# Access Compliance Report

## Public Rights-of-Way

Intersection ID: 19152	Main Street: E_INDEPENDENCE_BV	Cross Street: VILLAGE_LAKE_DR	Location: W
ADA ID: 27B68E4F2E70	Ramp Type: PerpDiag	Initial Pass/Fail: Fail	Overall Compliance: No
		Severity Score: 25

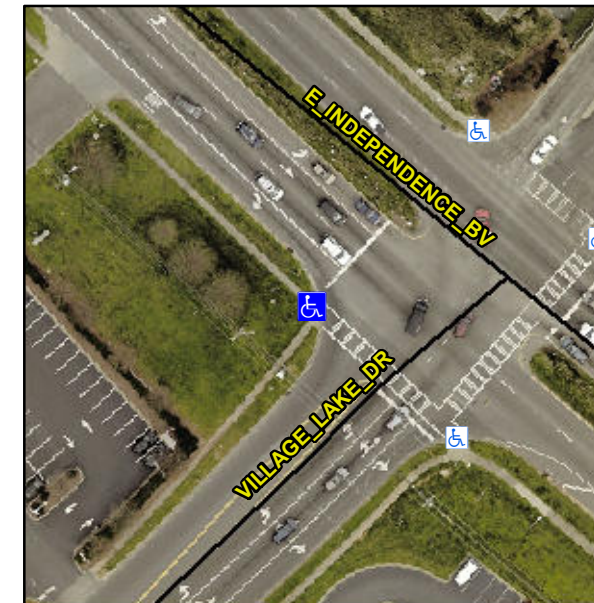
**R304.2.2**

Compliance	Description	Data	Compliance	Description	Data
N/A	Ramp Length (in)	48.0	No	Ramp Slope (%)	18.7
Yes	Ramp Width (in)	48.0	Yes	Ramp XSlope (%)	1.3
N/A	Flare Type LT	N/A	N/A	Flare Type RT	N/A
N/A	Flare Slope LT (%)	N/A	N/A	Flare Slope RT (%)	N/A
N/A	Flare Traversable LT?	N/A	N/A	Flare Traversable RT?	N/A
N/A	Landing Length (in)	N/A	N/A	DWS Provided?	N/A
N/A	Landing Width (in)	N/A	N/A	DWS Contrast?	N/A
N/A	Landing Slope (%)	N/A	N/A	DWS Length (in)	N/A
N/A	Landing X Slope (%)	N/A	N/A	DWS Full Width?	N/A
N/A	Landing Curb? (Y/N)	N/A	N/A	DWS Offset (in)	N/A
N/A	Shared Landing?	N/A			
N/A	Gutter Ponding?	N/A	N/A	Gutter Slope (%)	N/A
N/A	Gutter Lip Ht (in)	N/A	N/A	Gutter X Slope (%)	N/A
N/A	Painted X Walk1?	Yes	N/A	Painted X Walk2?	No
	X Walk 1 Direction	To SE		X Walk 2 Direction	To NE
N/A	X Walk 1 Width (in)	108.0	N/A	X Walk 2 Width (in)	N/A
	X Walk 1 Slope (%)	0.7		X Walk 2 Slope (%)	2.3
	X Walk 1 X Slope (%)	2.9		X Walk 2 X Slope (%)	1.5

**Remove & Replace Curb Ramp With Two New Directional Ramps or Equivalent.**
